From: Robert Rule [Bob@demaximis.com]
Sent: Friday, June 14, 2013 12:48 PM
To: Thompson, Owen; William Earle
Cc: Gerard Caron; Wayne Reiber; Joseph Heimbuch; Tom Steib; Felitti, Peter; Rick Mason; Ralph Cascarilla
Subject: Fields Brook Action Group Comments to Detrex DNAPL Report
Attachments: Comments_DetrexDNAPLRecReport.pdf

FBAG Comments on DNAPL Recoverability Evaluation Report
Dated April 12, 2013
Fields Brook Superfund Site, Ashtabula, Ohio

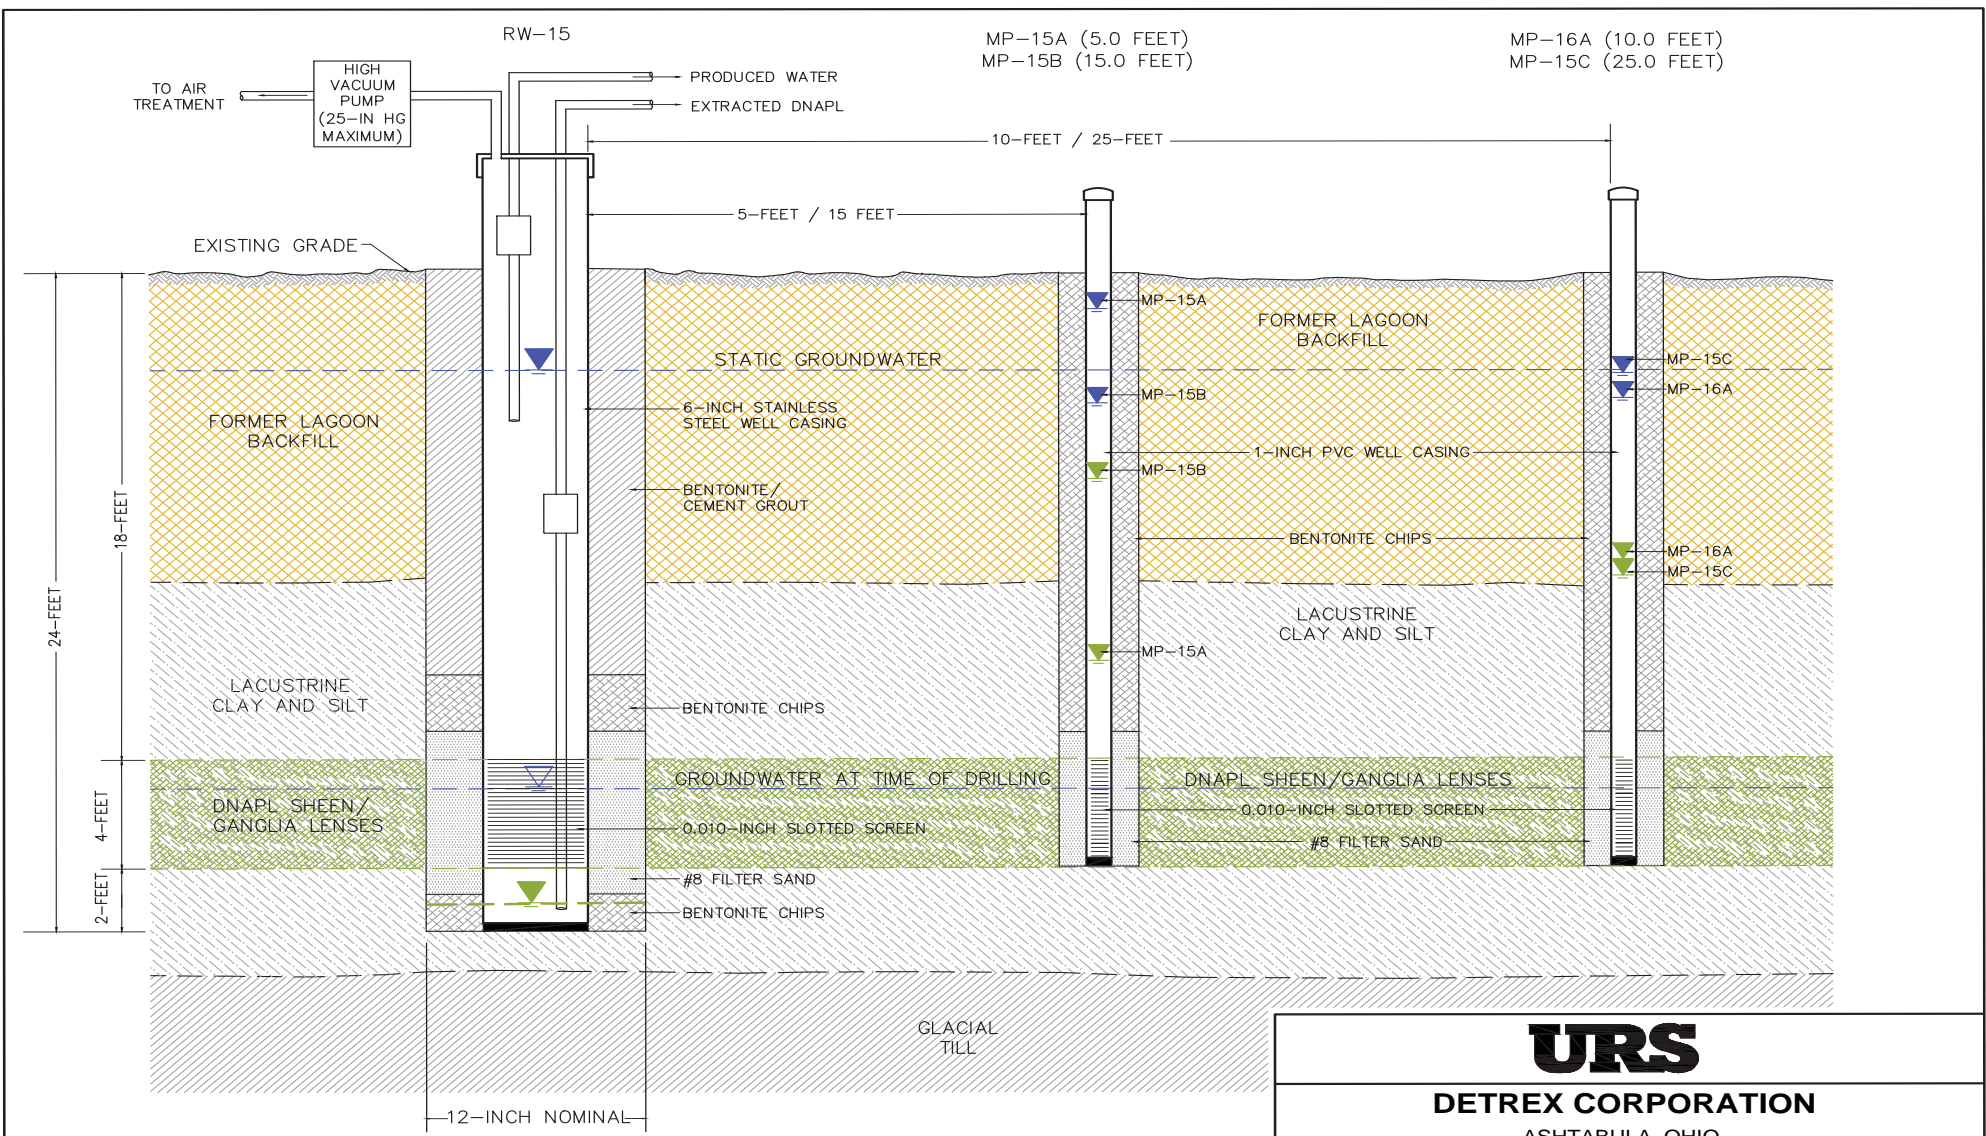
3. The DNAPL recoverability pilot testing results indicate that significant DNAPL recovery rates were achieved and could be potentially improved and sustained with a properly designed full-scale system.

- *DNAPL Recovery Rate:* Detrex's characterization of the recoverability testing findings is misleading, given that the highest reported DNAPL recovery rate was 28.8 gallons per day (gpd). Furthermore, the average DNAPL recovery rates ranged from 17 to 27.5 gpd for procedures 2 through 4. These measured DNAPL recovery rates are appreciable and would result in the recovery of thousands of gallons of DNAPL per year from the pilot wells alone, if sustained (see below for further discussion regarding sustainability). Further, the average DNAPL recovery rate measured for each procedure is biased low, since in most of the tests, the applied vacuum was increased during the course of the test, which resulted in a decrease in DNAPL recovery rates. Thus, if the recovery wells were adjusted and operated at optimal vacuum, it is likely that higher DNAPL recovery rates would have been achieved.
